PCB 07-00985 ISSUE 11

SCALE 2:1		© CODAN PTY LTD, A.C.N. 007 590 605: 1997	
	DRN	MB	TITLE	
MATERIAL	CHKD	NJA 18-8-86	AUDIO & IF 1650 KHz PCB	
FINISH	APPD	NJA 30-10-86	DRAWING/DOC NO.	
TOLERANCES UNLESS OTHERWISE STATED			A3 08-03025	
2 PLACES DEC.			ISS	
1 PLACE DEC. ±0.5			11 12 13 14	
0 PLACE DEC. ±1			SHT. 1	
ANGULAR ±2°			OF 1

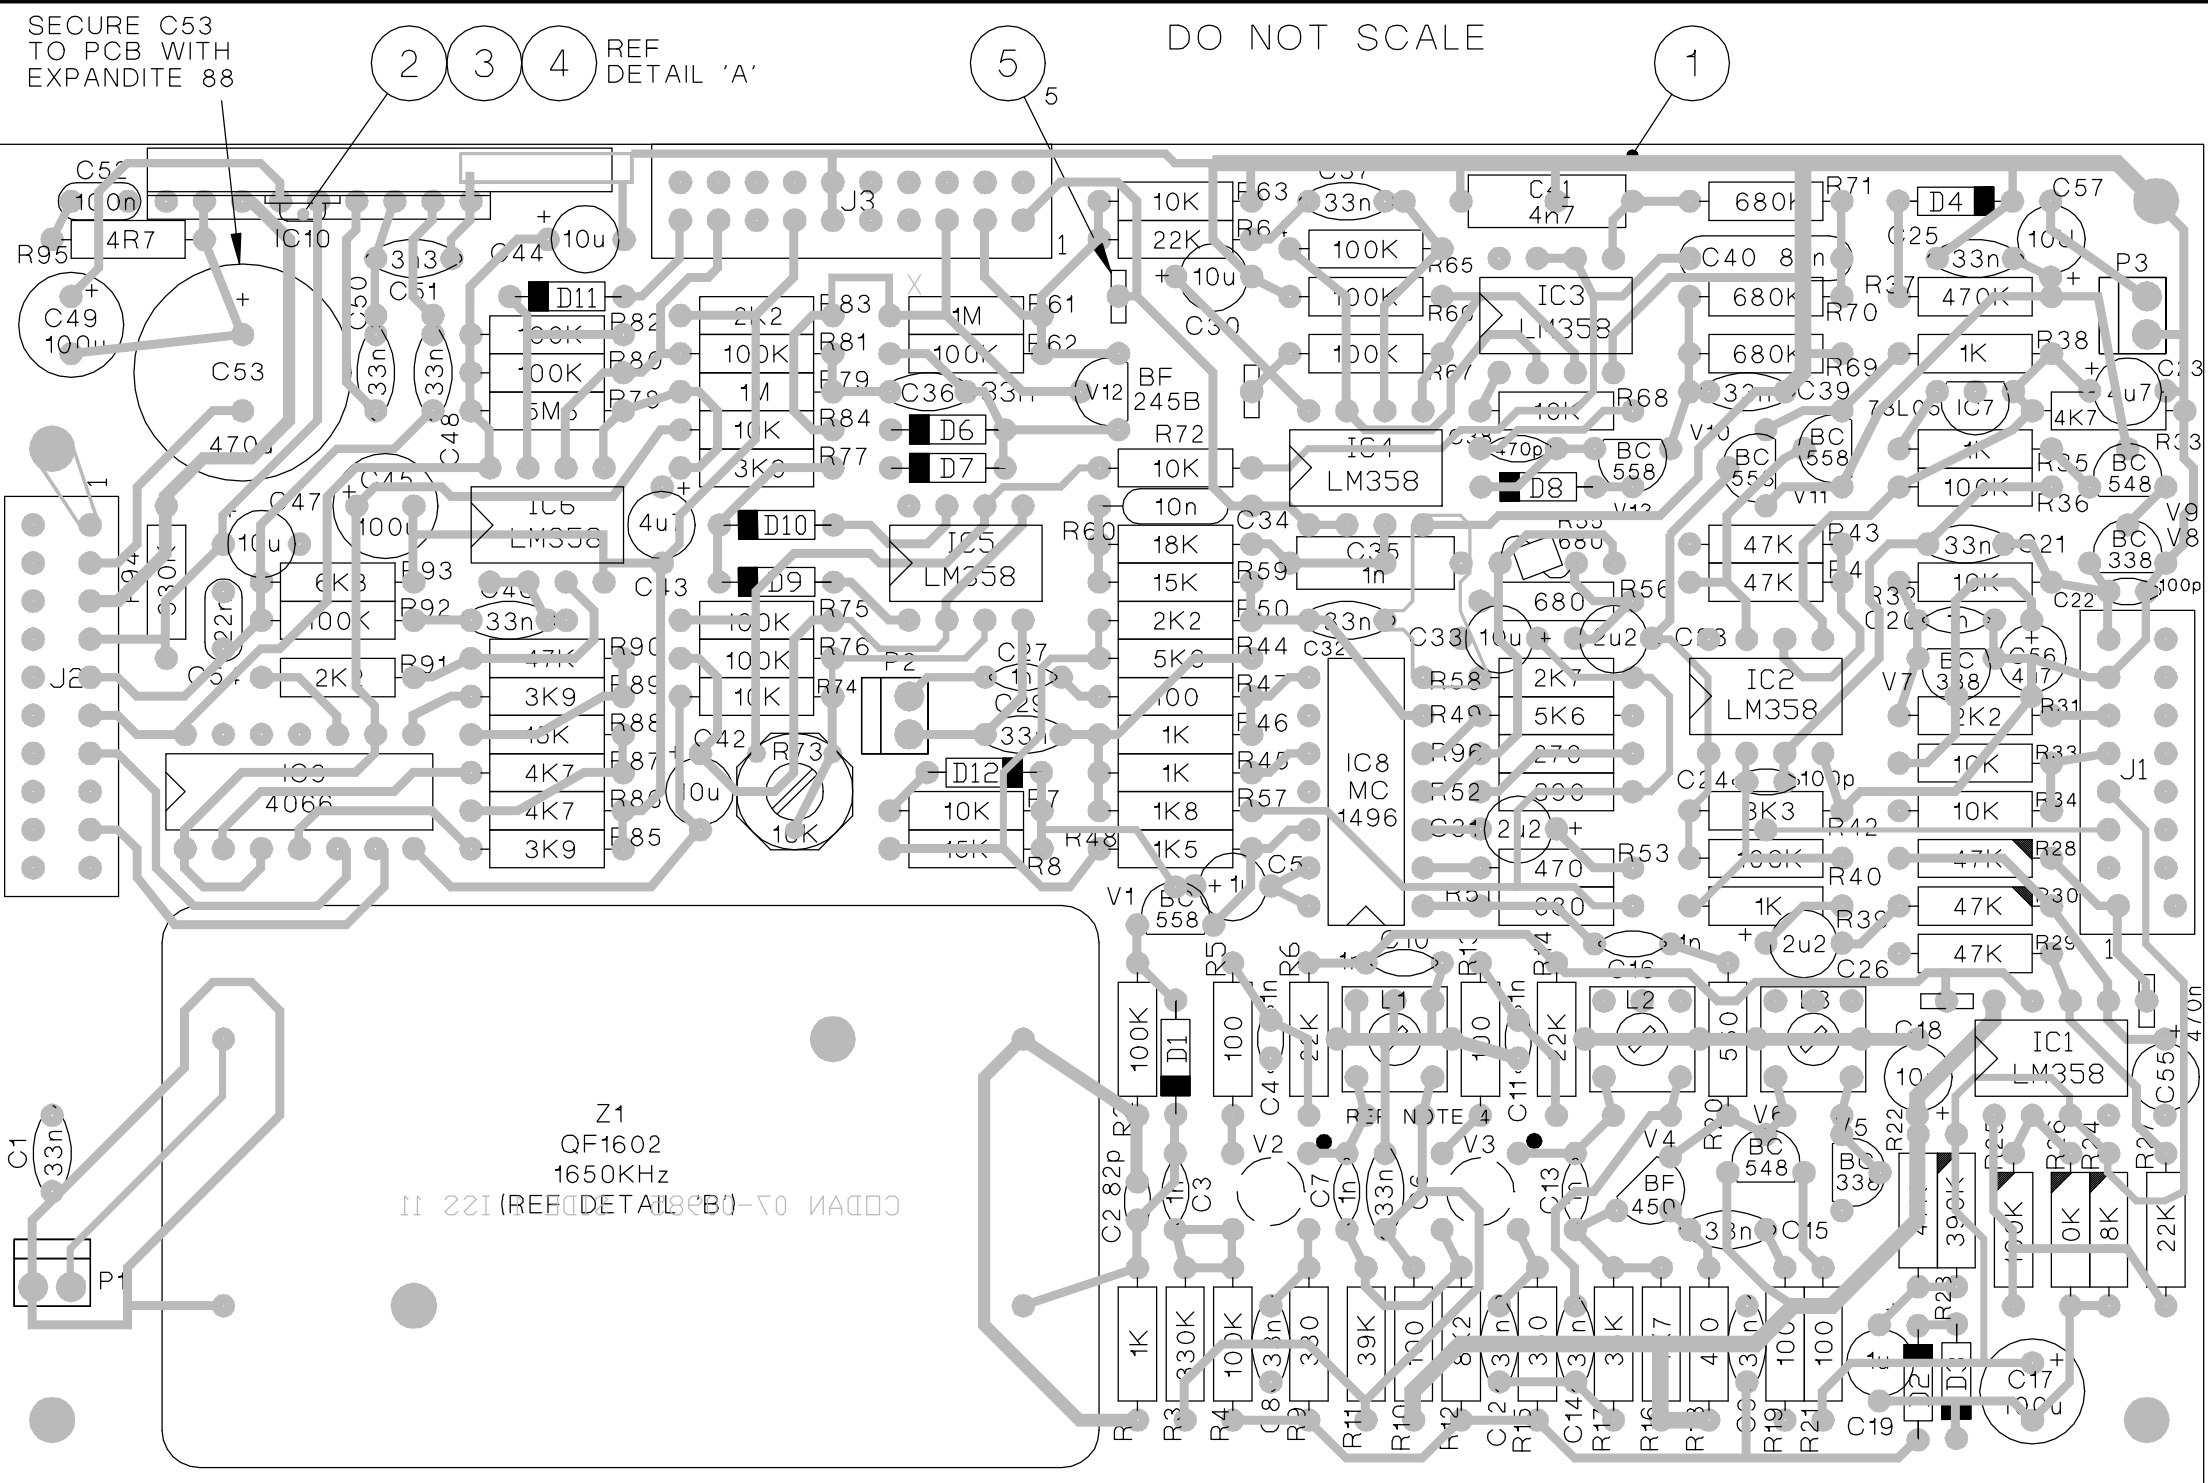
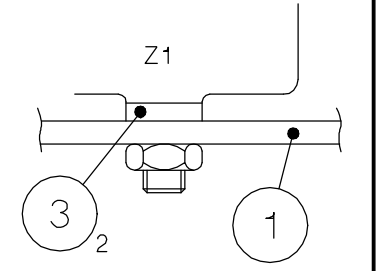
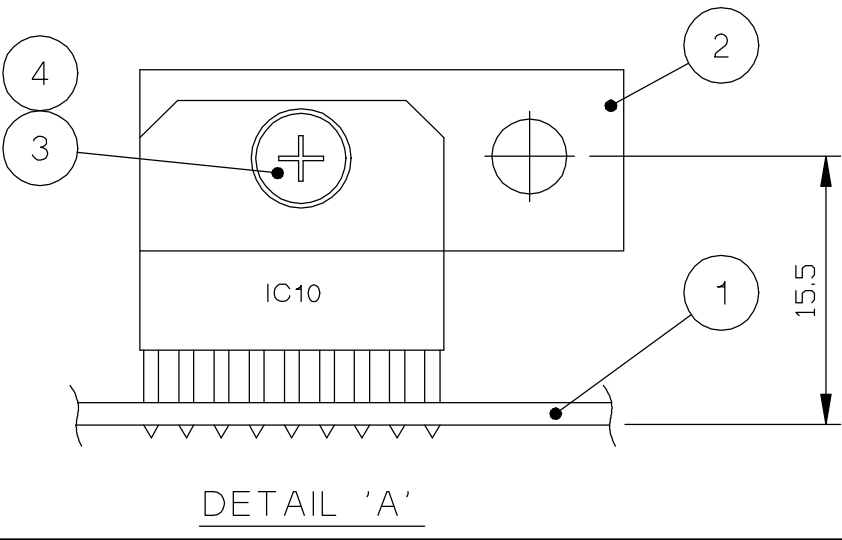
ISSUE 9
C54 WAS 100p
C57 ADDED
C/R 22496
20-8-90 NJA

ISSUE 10
C55 WAS 100n
R28 & R30 WERE
68K
C/R 22538
29-8-90 NJA

ISSUE 11
R52 WAS 470
R96 WAS 330
C/R 23587
4-3-93 NJA

ISSUE 12
R97 ADDED
C/R 23689
29-9-93 NJA

ISSUE 13
P3 ADDED
C/R 24314
2-8-95
C57 WAS 1u
C/R 24319
7-8-95 NJA

ISSUE 14
V2 & V3 WERE
3SK85
C/R 24597
10-5-96 NJA

ISSUE 2
C56 ADDED
C/R 21271
V7 WAS BC548
C/R 21257
8-4-87 NJA

ISSUE 3
ITEM 3 ADDED
BETWEEN Z1
& PCB
C/R 21289
10-6-87 NJA

ISSUE 4
PCB WAS ISS. 4
R54 DELETED
R52 WAS 1K
R55 WAS 1K3
C/R 21339
29-9-87

ISSUE 5
R55 680 WAS
R52 820
C/R 21414
11-2-88 NJA

ISSUE 6
R36 WAS 47K
R95 ADDED
C/R 21621
22-9-88 NJA

ISSUE 7
3SK85 WAS BF981
(V2 & V3)
C/R 21999
22-6-89 NJA

ISSUE 8
C25 WAS 1u
D5 DELETED
R37 DET ADDED
C/R 22442
26-4-90 NJA
